**JORDAN VALLEY WATER CONSERVANCY DISTRICT
INFRASTRUCTURE SERVICES FACILITY FENCE
PROJECT
DISTRICT PROJECT NO. 4413**

ADDENDUM NO. 1

INFRASTRUCTURE SERVICES FACILITY FENCE	
DEMOLITION PLAN

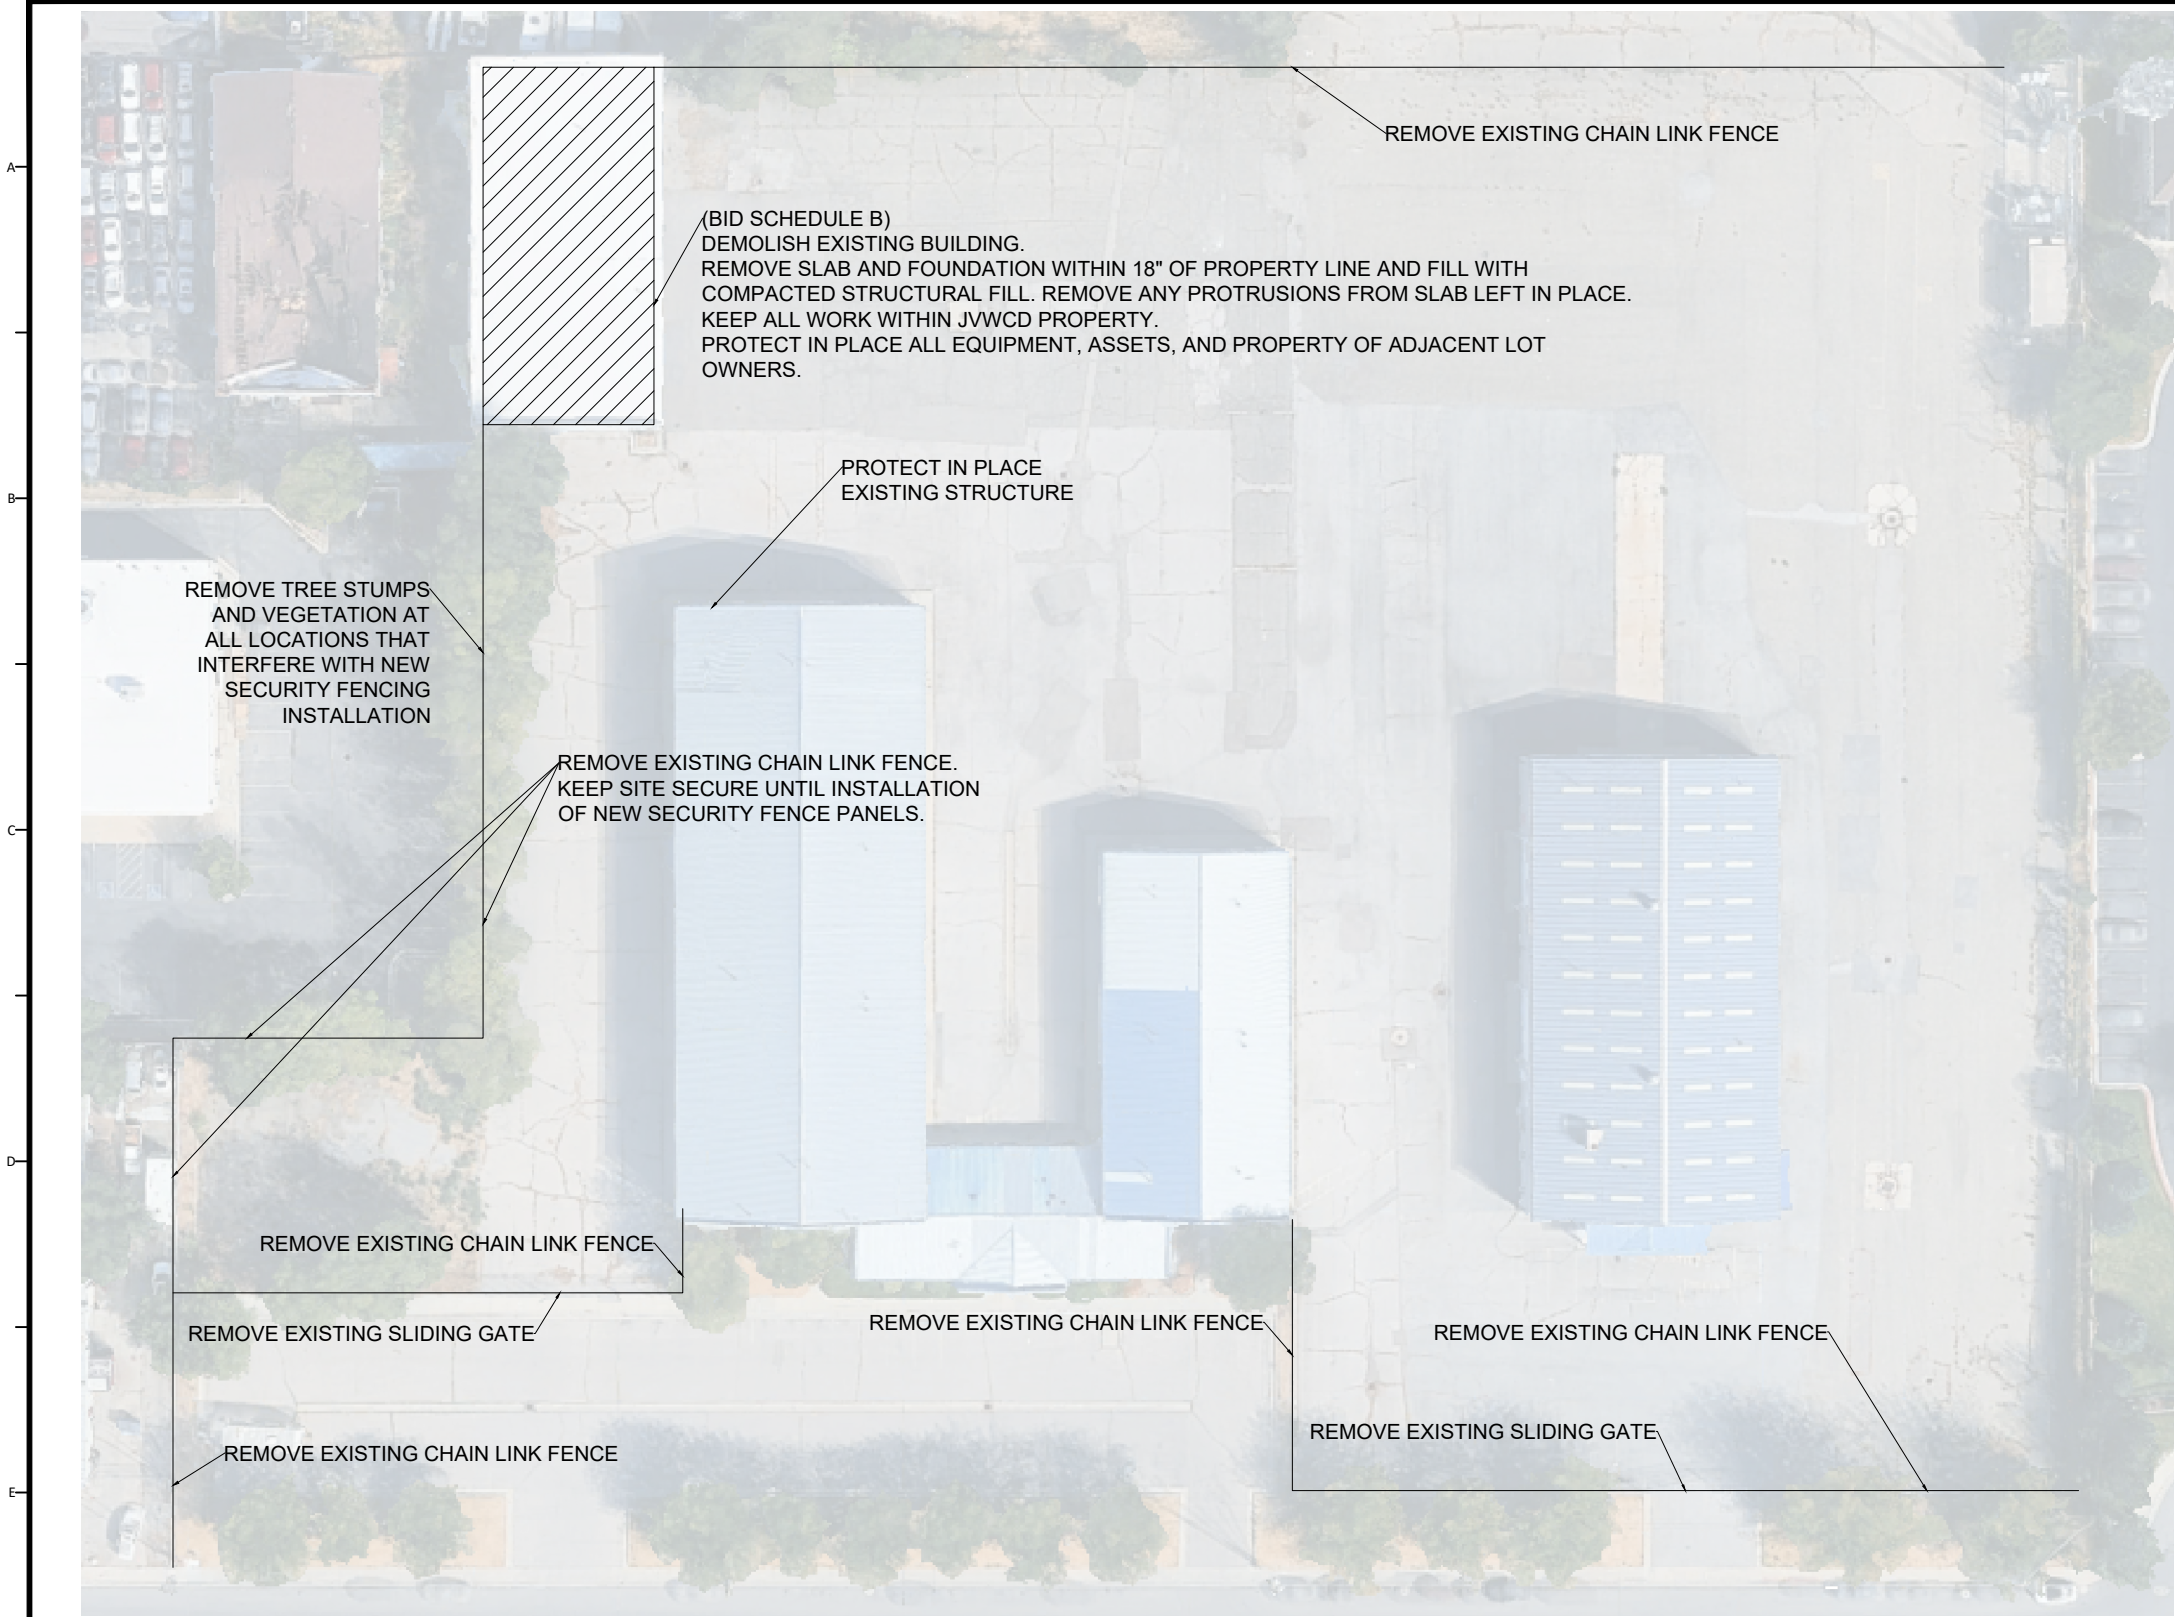
- 1.1.1 Drawing M1, "REMOVE SLAB AND FOUNDATION WITHIN 18" OF PROPERTY LINE AND FILL WITH COMPACTED STRUCTURAL FILL. REMOVE ANY PROTRUSIONS FROM SLAB LEFT IN PLACE" has been added to the callout for building demolition.

- 1.1.2 Drawing M1, "EXISTING FENCE POSTS EMBEDDED IN CONCRETE THAT WILL BE REMOVED MAY BE CUT, GROUND TO BE FLUSH WITH CONCRETE, AND FILLED WITH GROUT" has been added as a note.

3. Some existing fence posts are embedded in a concrete curb wall. Do we cut the posts or remove the curb wall along with the posts?
 - a. Fence posts may be cut and then ground down to flush with the concrete curb and filled with grout. A detail has been provided in the drawings as part of this addendum.

- a. Slab and foundations shall be removed within 18” of property line and filled with compacted structural fill. Remaining slab and foundations can be left in place with any protrusions being ground flat so that entire slab is flat with no obstructions.

- 13. Does Bid Item B-3 include removing the slab and footings? If so, does “matching surface” mean new asphalt paving, and to what section?
 - a. The slab and footings within 18” of the property line will be included, as indicated on the revised drawings. That strip will be filled with compacted structural fill. The remaining slab outside of that strip may be left in place, and any protrusions extending off the slab be ground down flush with the slab and smoothed.

- NOTES:
- EXISTING FENCE POSTS EMBEDDED IN CONCRETE THAT WILL BE REMOVED MAY BE CUT, GROUND TO BE FLUSH WITH CONCRETE, AND FILLED WITH GROUT.

INFRASTRUCTURE SERVICES FACILITY FENCE	
LAYOUT PLAN

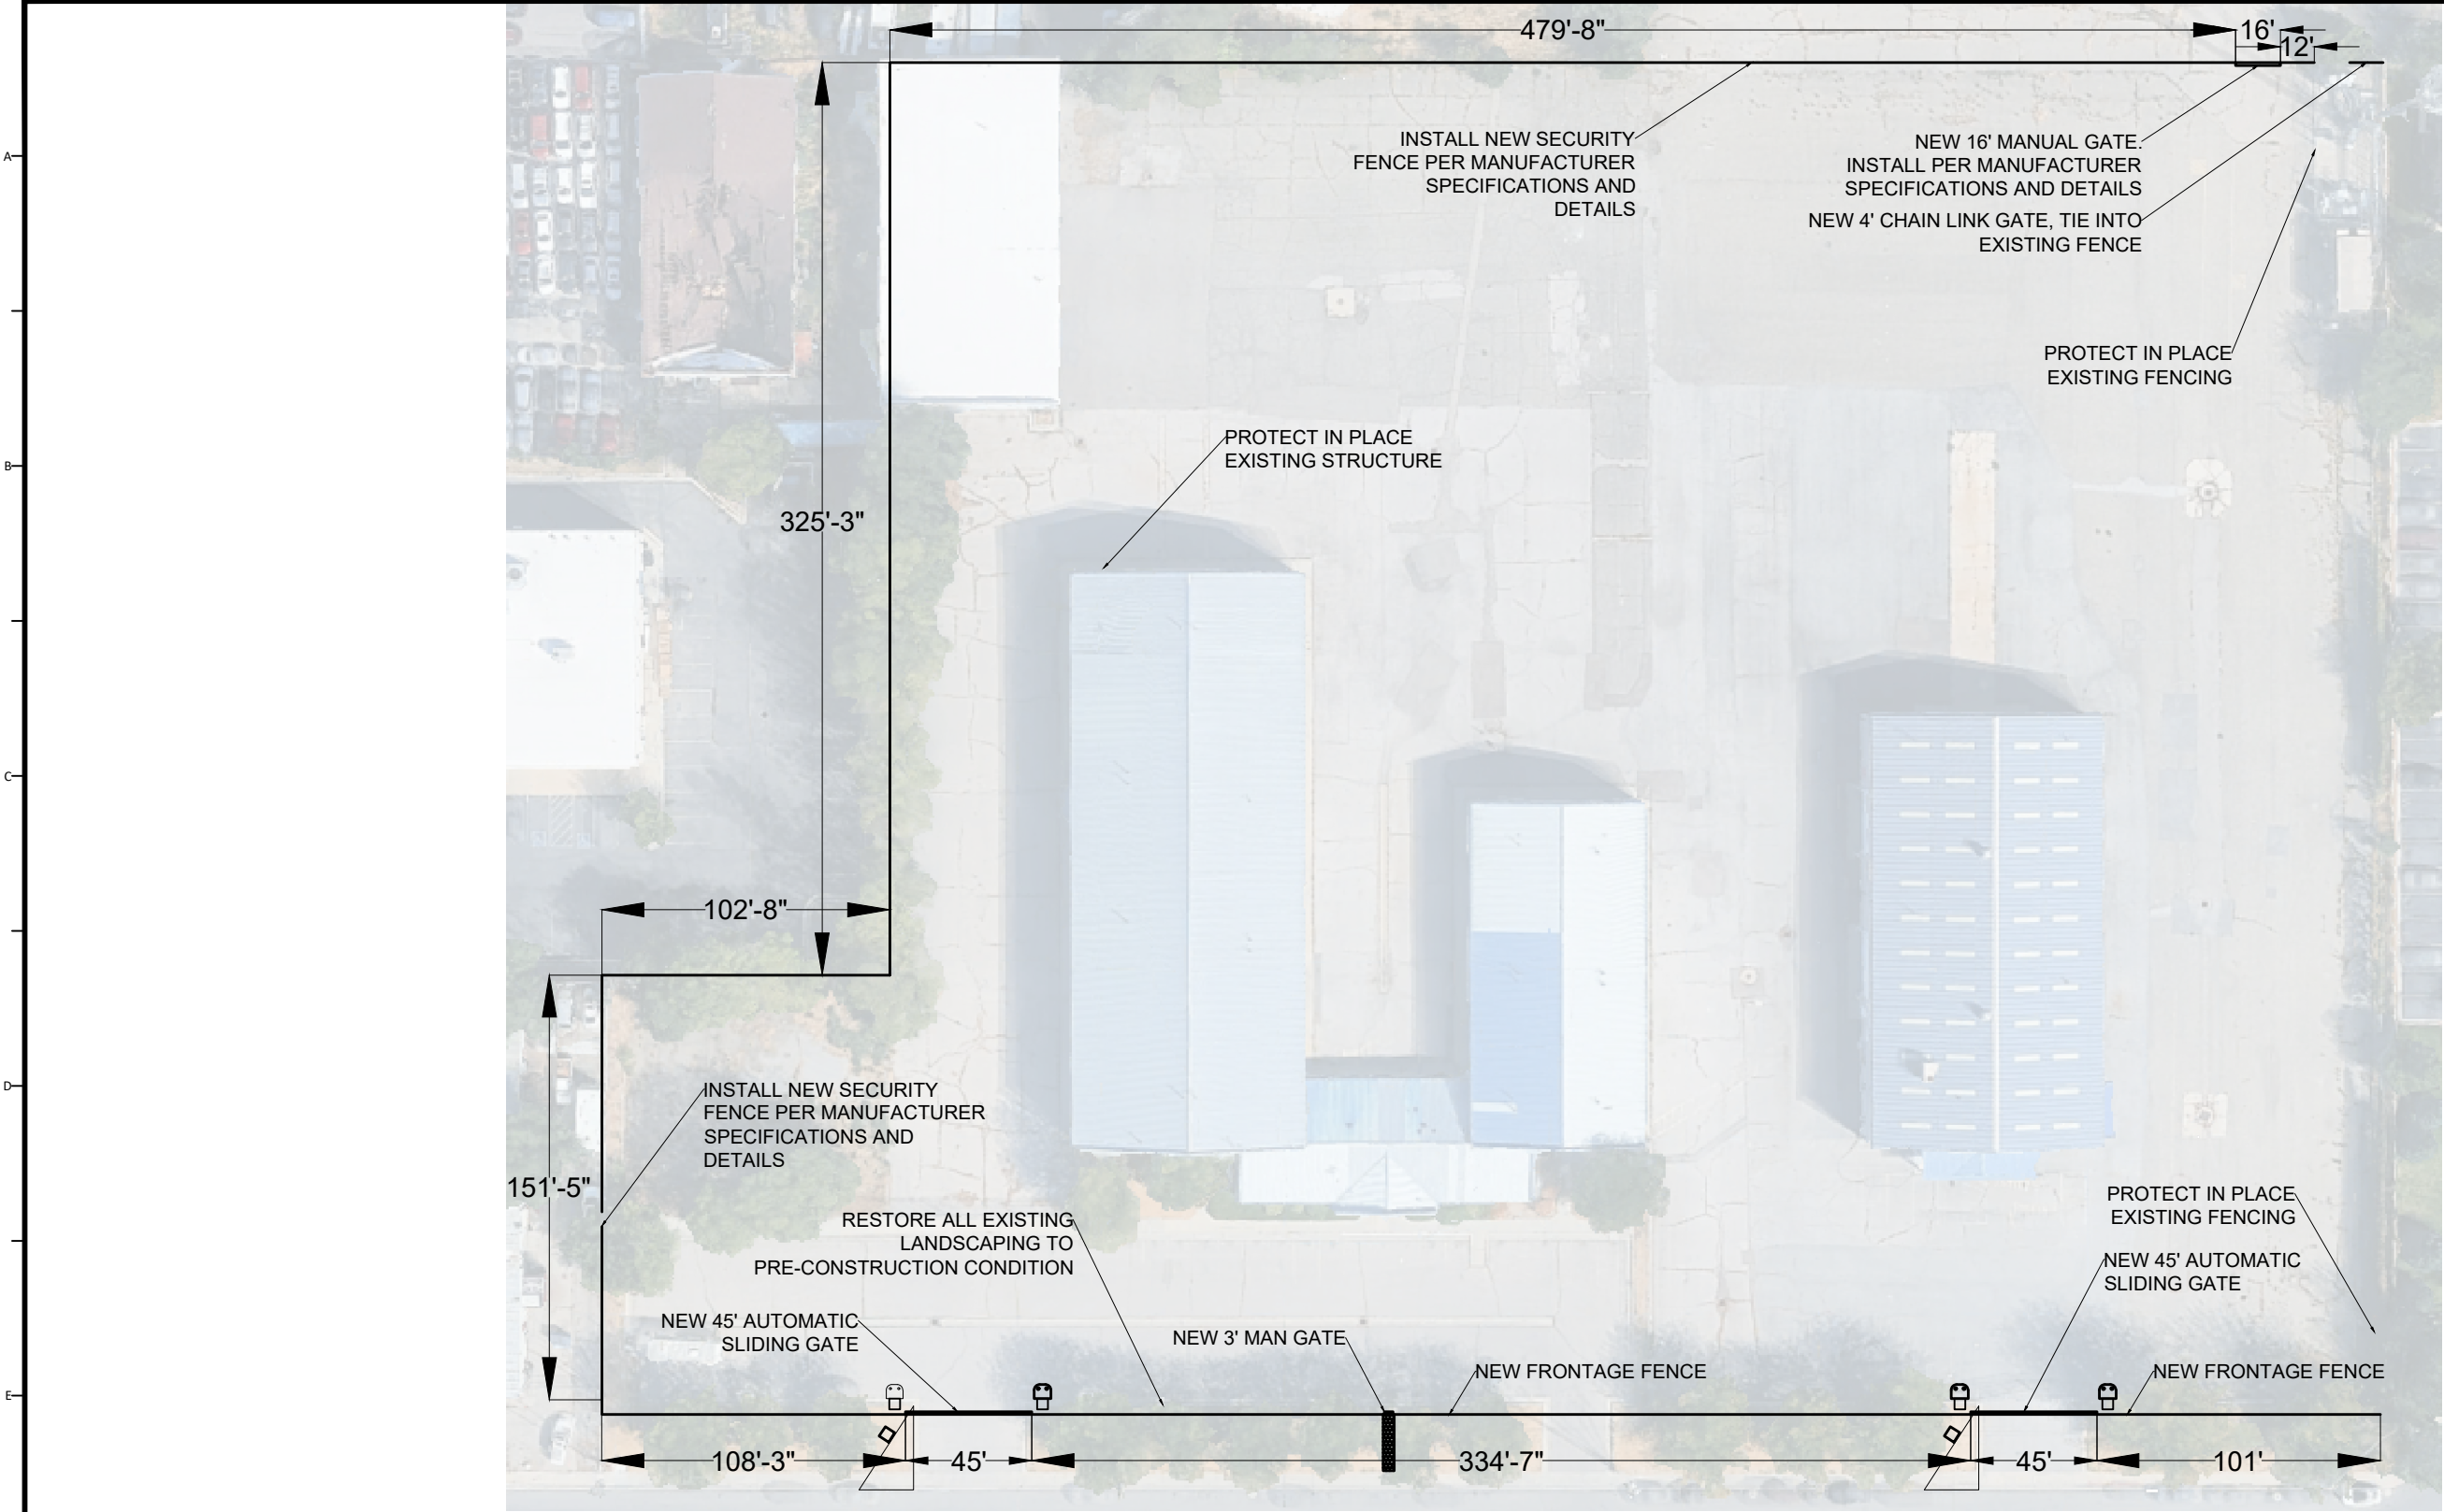
- 1.1.3 Drawing M2, callout has been added indicating location of 4' chain link man gate will be installed.
- 1.1.4 Drawing M5, post callout has been updated to "3" X 3" X 12GA MIN SQ TUBE POST W/CAP"

INFRASTRUCTURE SERVICES FACILITY FENCE	
DETAILS

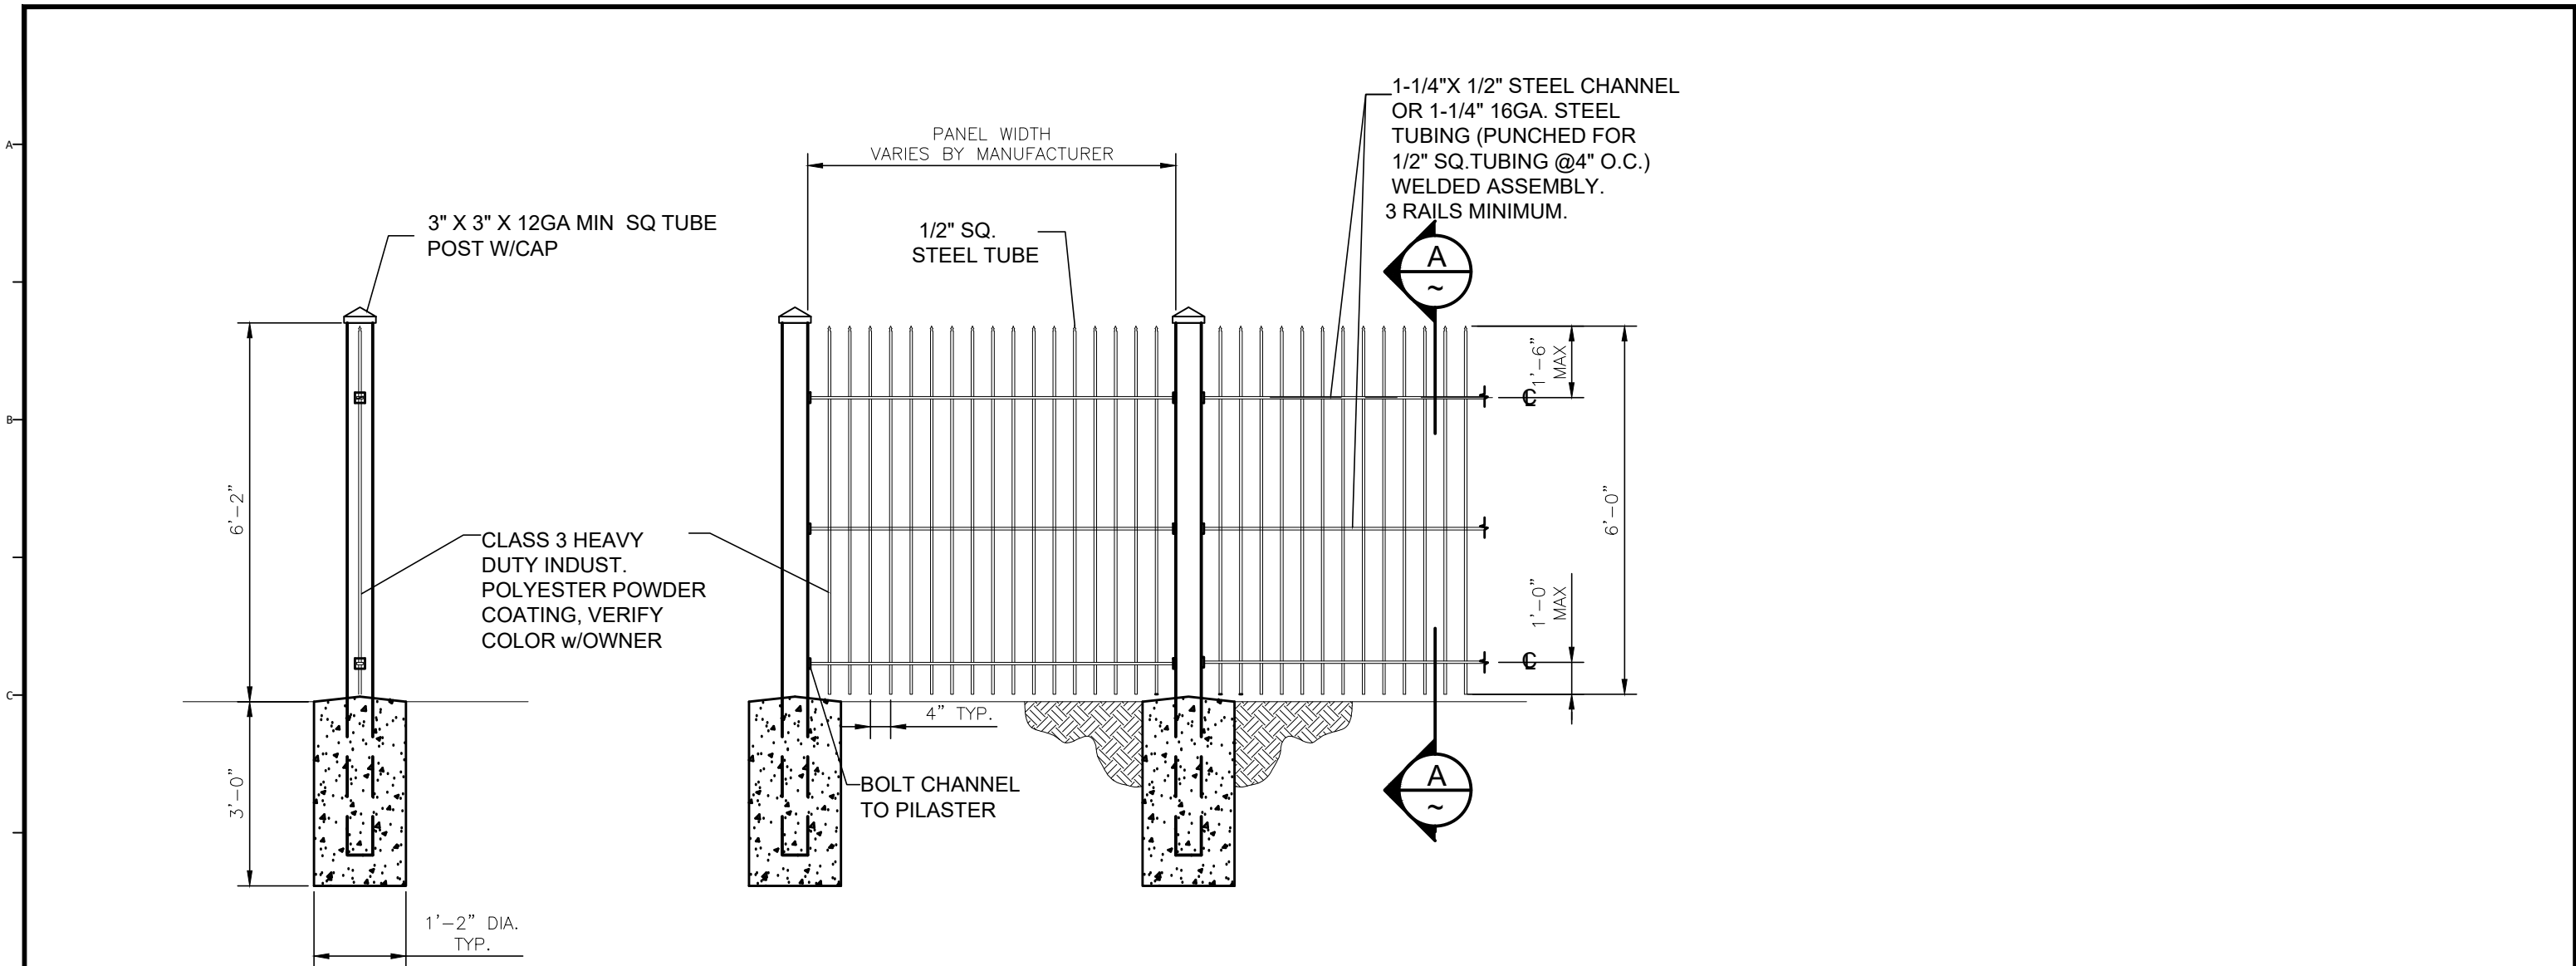
- 1.1.5 Drawing M5, panel width dimension has been updated to "PANEL WIDTH VARIES BY MANUFACTURER"
- 1.1.6 Drawing M5, rail callout has been updated to include "3 RAILS MINIMUM"

- 1.1.7 Drawing M5, dimensions of rail locations have been updated.
- 1.1.8 Bidding Documents page A-1, "DESCRIPTION OF WORK" paragraph has been updated to the following: "This project includes removal of a portion of the chain-link fence around the site perimeter, removal of tree stumps that obstruct the fence path, and the installation of new security fence, frontage fence, two automatic sliding gates, one manual gate, one ornamental man gate, one chain link man gate, and demolition of a vacant building."
